TOPIC: 494 S Broadway Site Plan Review

494 S. Broadway - Cloud Retail - Site Plan Review #3 - March 28, 2023

Subject: 494 S. Broadway Street (M-24): Cloud Retail - Site Plan Review #3

C-1

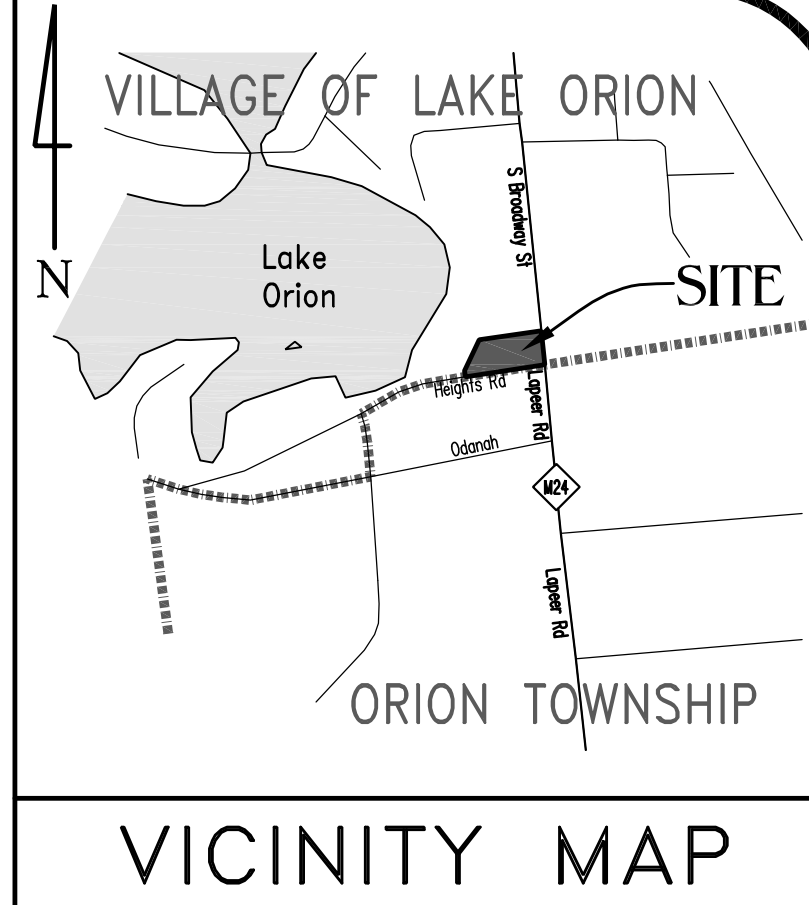
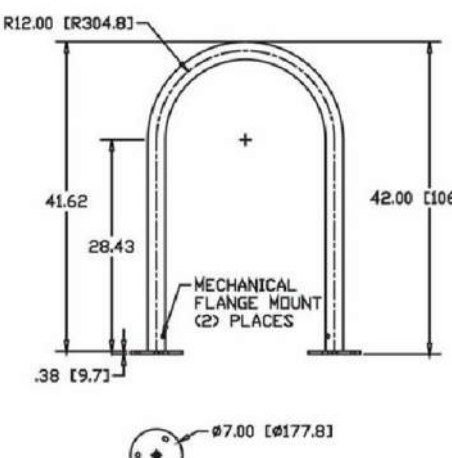
The Site Data on Sheet C-1 details a common area calculation of approximately 33%; however, this calculation does not distinguish between the required sidewalks/landscaping and additional open space/amenities; this distinction must be provided.

Five rain gardens are included, and the internal 6-foot sidewalk is proposed as permeable concrete (as detailed on Sheet C-1). The rain gardens are still smaller in size and the steepness of the grades surrounding them will likely decrease their effectiveness. Creating a larger garden would be more beneficial to the site; it is recommended that the gardens are enlarged to maximize effectiveness (see diagram under Item 5).

SITE LIGHTING/PHOTOMETRIC PLAN

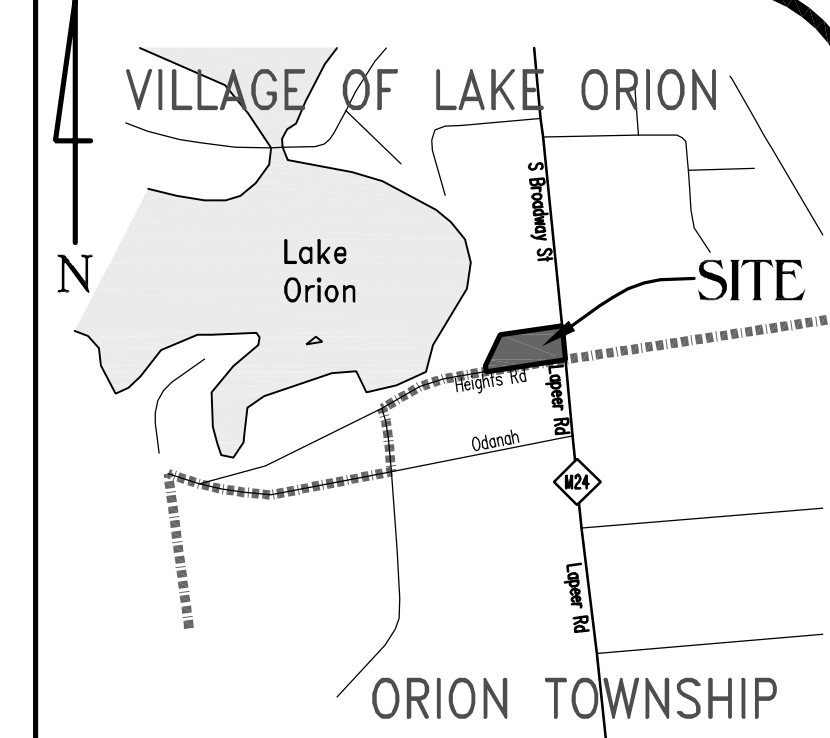
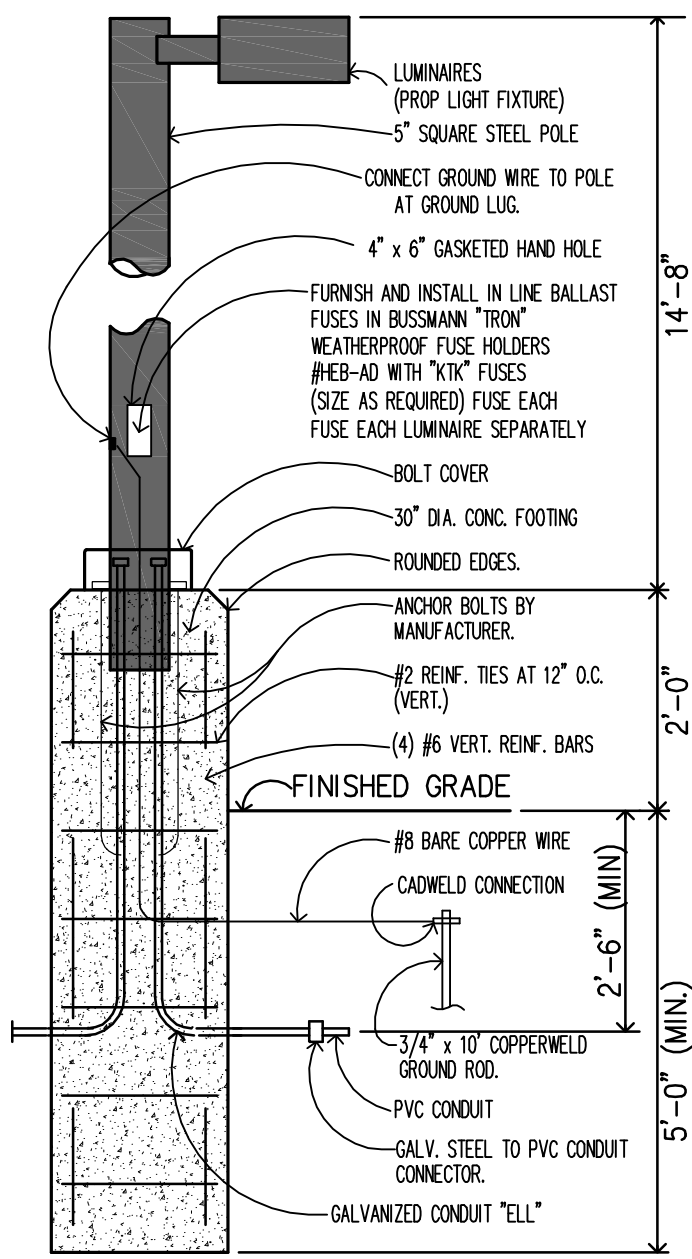
Findings: Overall, the proposed lighting complies with ordinance requirements. Both building mounted and freestanding pole lighting are proposed for the development and detailed on Sheet C-11; this now includes

decorative sconce lighting for the north and east elevations, as seen on Sheet A3.1. A cut sheet for the sconces must be provided and these fixtures must be reflected on the photometric plan, which still shows the previous wall packs and incorrect fixture locations and mounting heights.

Conceptual Landscape Plan

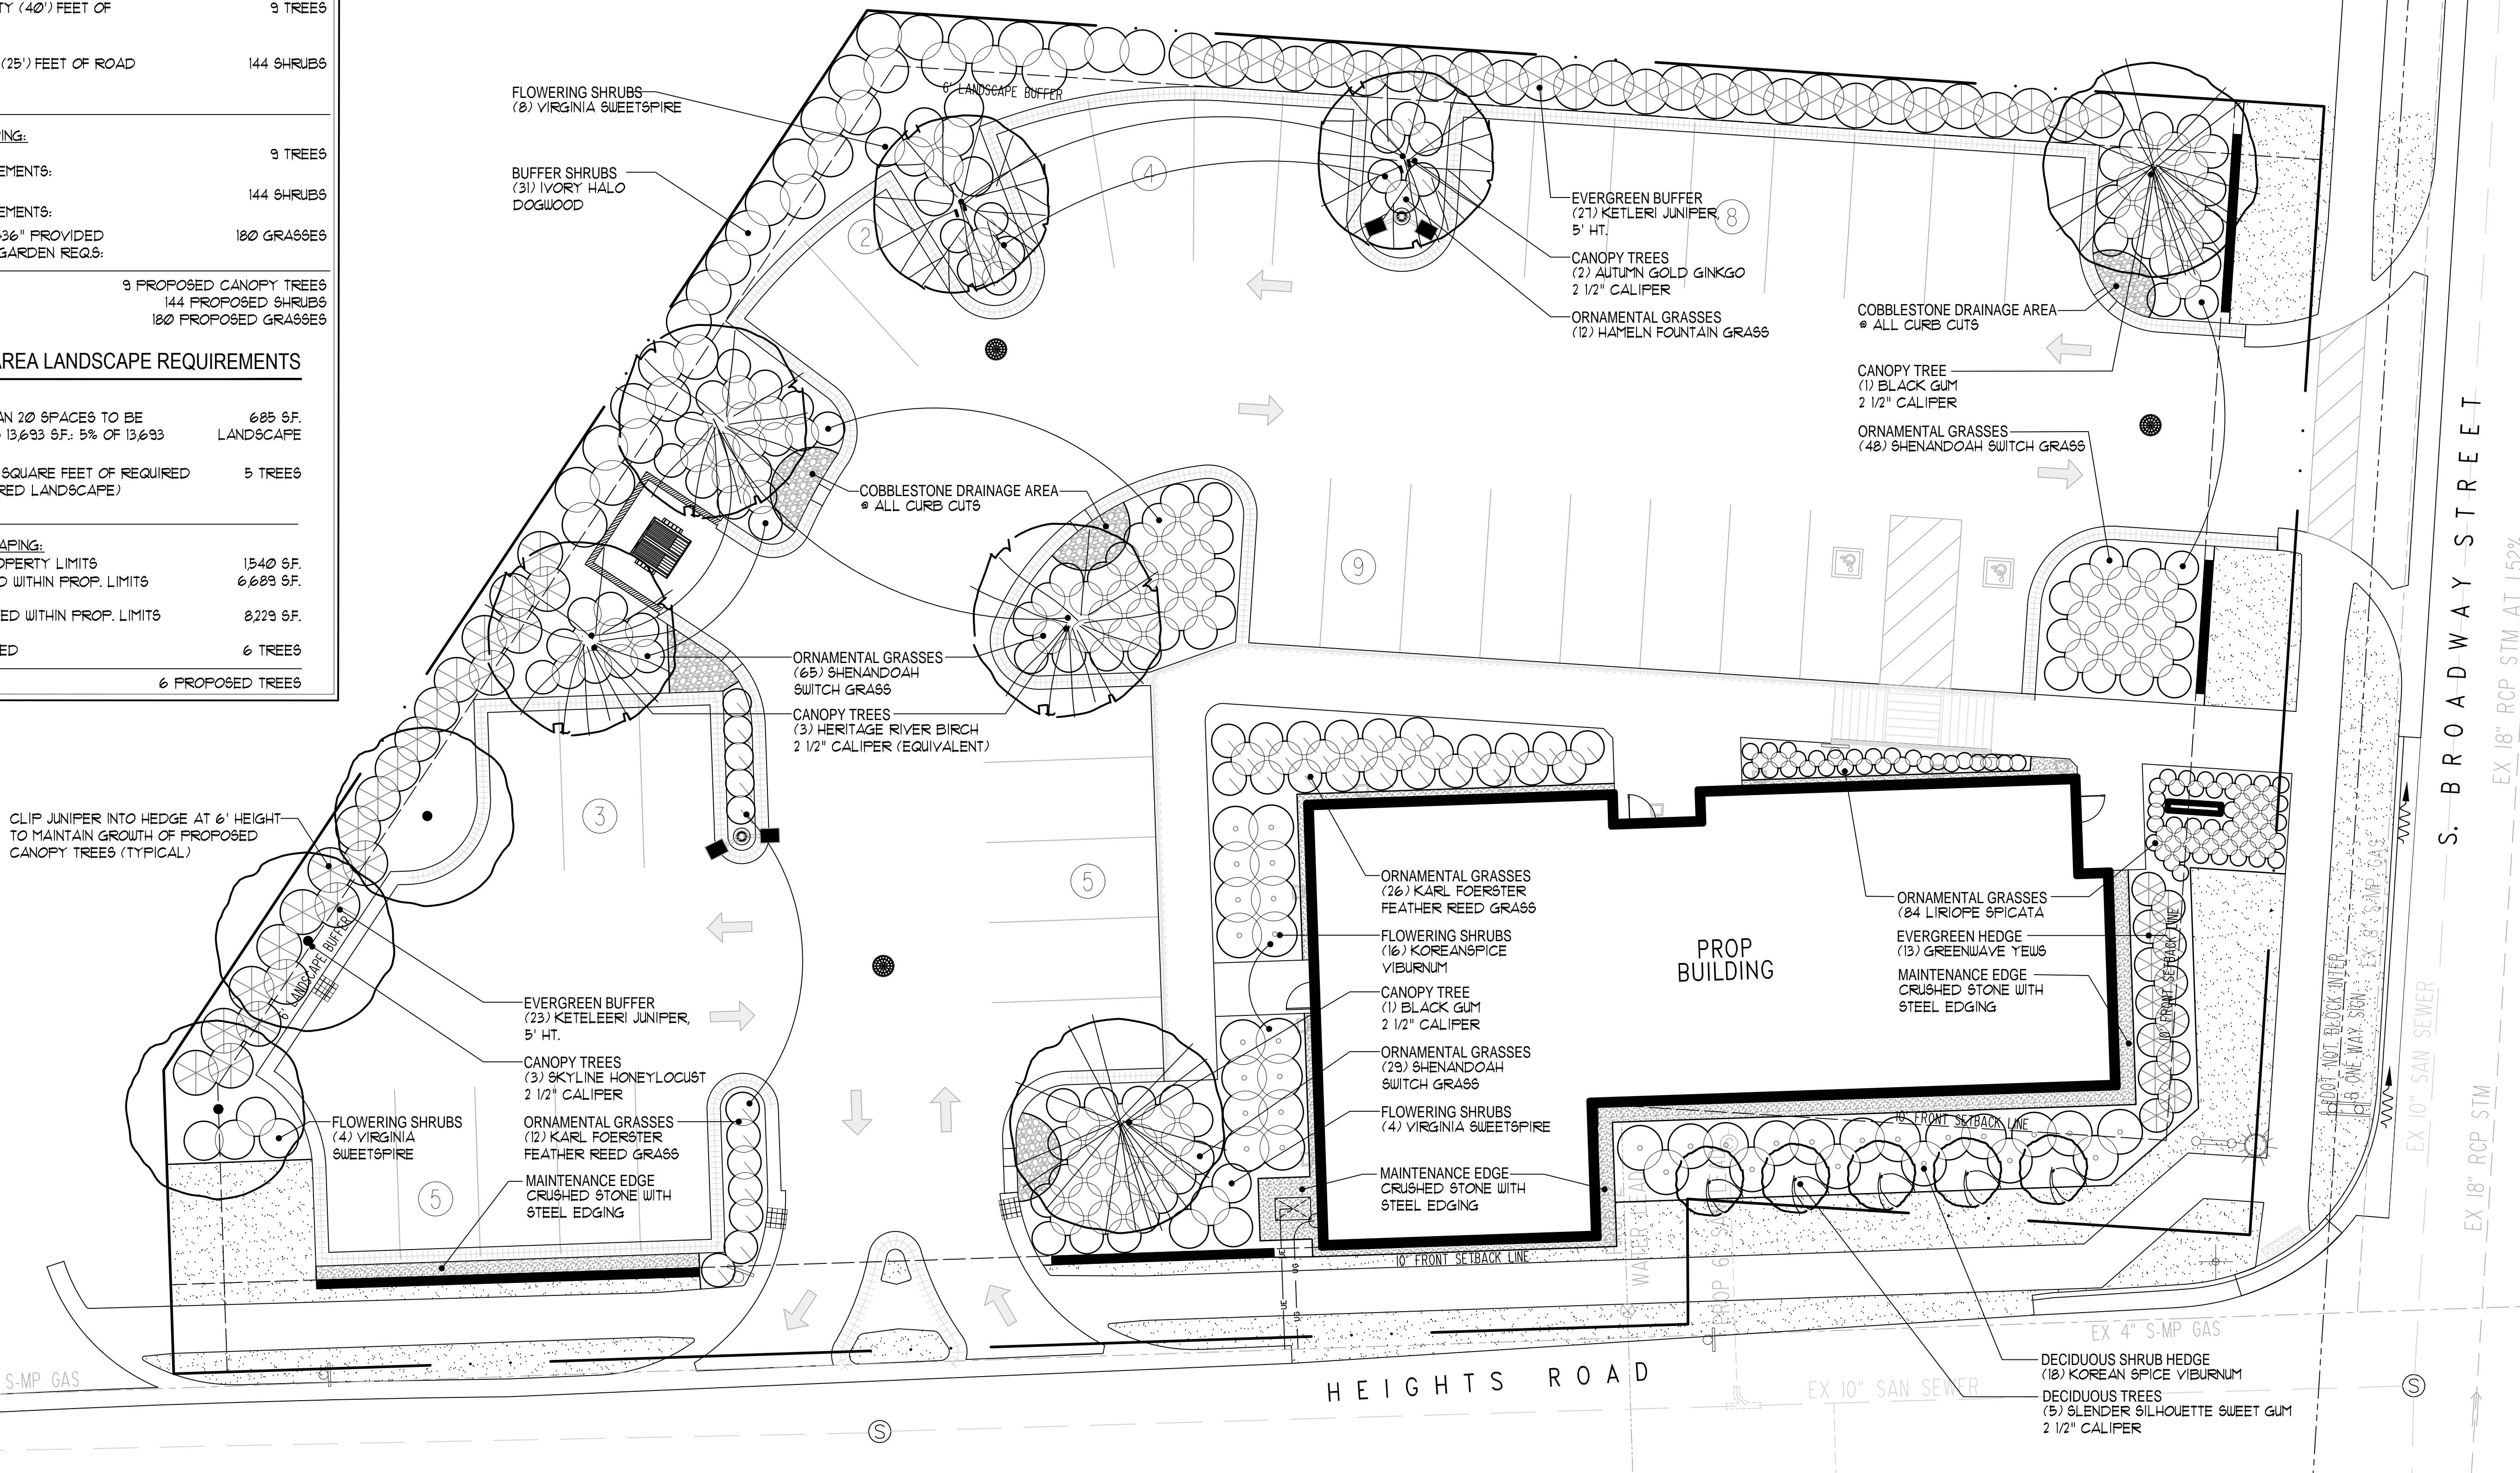
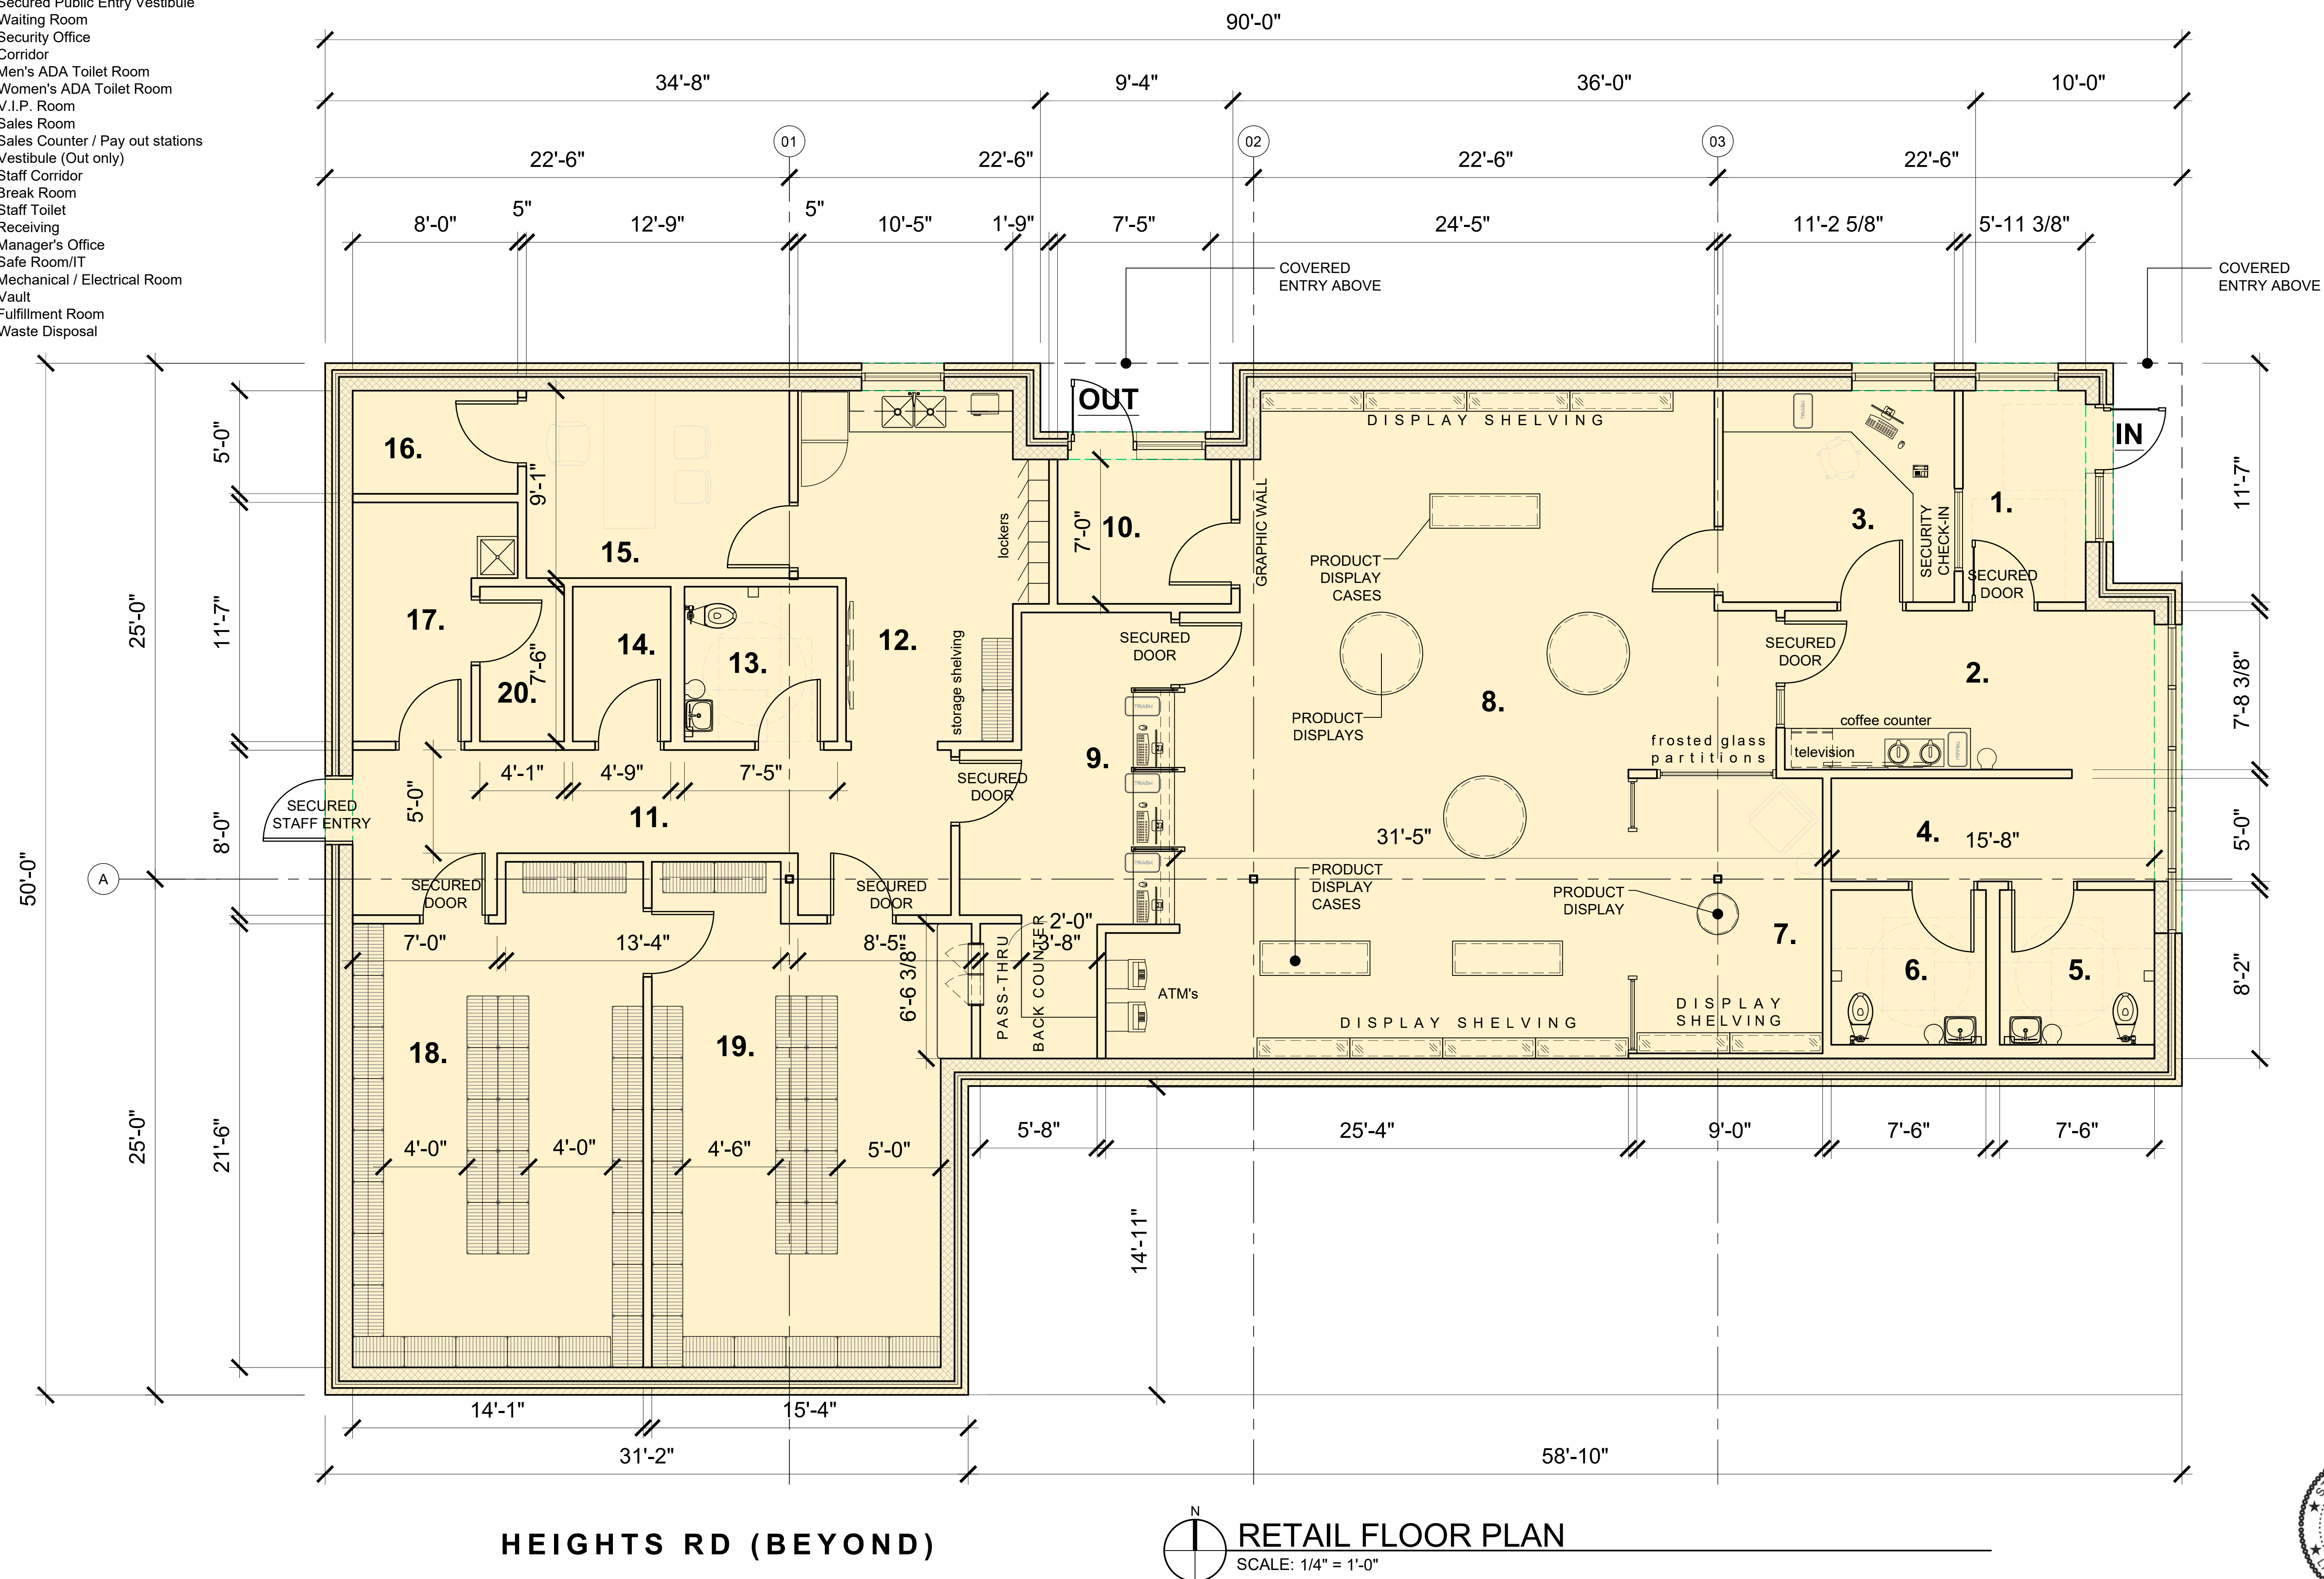
- **General Site Landscaping and Plant Materials.** In total, the Landscape Plan (L1) details the addition of 15 deciduous trees, 144 shrubs, and 276 ornamental grasses which are to be installed along the S. Broadway, Heights Street, and interior property lines, and throughout the interior of the subject site.

Per section 15.02, no single tree species can account for more than 20% of the plant material provided (in order to create more diversity than currently present at the site today). The applicant has since revised their plans to account for greater diversity, satisfying this requirement.

For this project, the Landscape Plan (L1) details a 6-foot-wide greenbelt with a mix of shrubs along the north and west property lines. Most of the greenbelt is comprised of an evergreen hedge using 50 5-foot Ketleri Juniper shrubs. Additional plantings of Virginia Sweetspire shrubs have been incorporated within the parking lot islands.
